Sheet: /
 File: working.kicad_sch

Title: UTCape

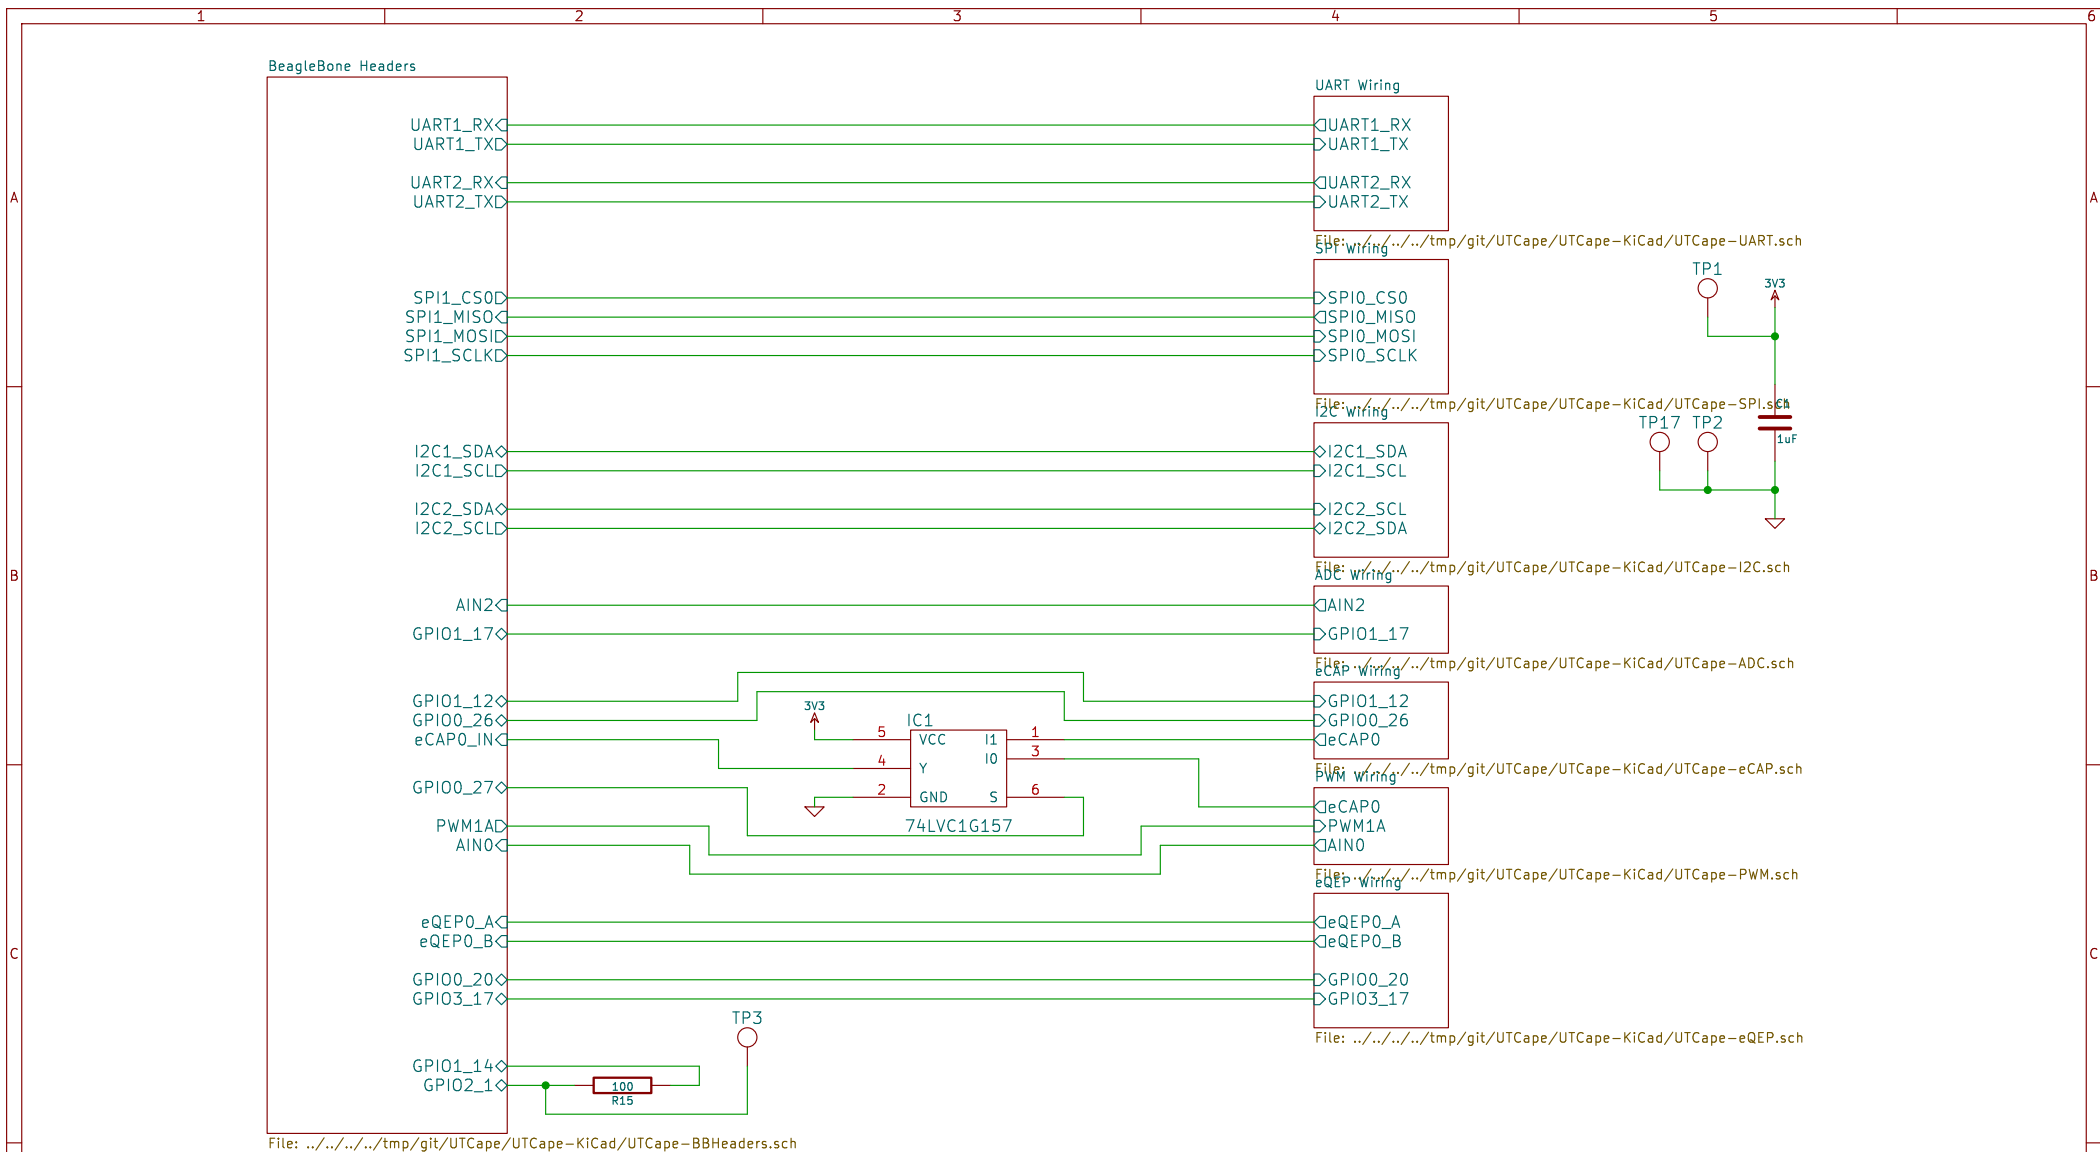
1. Is IC1 really needed, or am I just not seeing a second eCAP input?
